APPLICATION NO.	FILING DATE	FIRST NAMED INVENTOR	ATTORNEY DOCKET NO.	CONFIRMATION NO.
09/943,685	08/30/2001	Terry Loughrin	6039-000293	1262

Office Action Summary

DETAILED ACTION

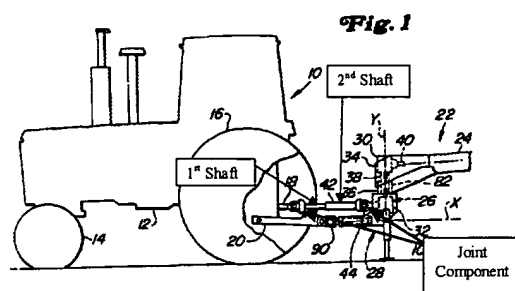
In regards to claim 1, in Figure 1 below, Walters et al discloses a drive shaft assembly (42) for interconnecting a driving component (10) of an agricultural machine and a driven component (22) of an agricultural implement, comprising a first shaft; a second shaft engaging the first shaft for enabling torque transmission and relative axial sliding motion therebetween; and a joint component of a universal joint operably interconnecting one of the first and second shafts to one of the agricultural driving and driven components, the joint component is both rotatable through a specified range of rotation and is fixed from axial movement relative to one of the second shaft, the agricultural driving component of the agricultural machine and the agricultural driven component of the agricultural implement. Walters et al does not disclose the joint
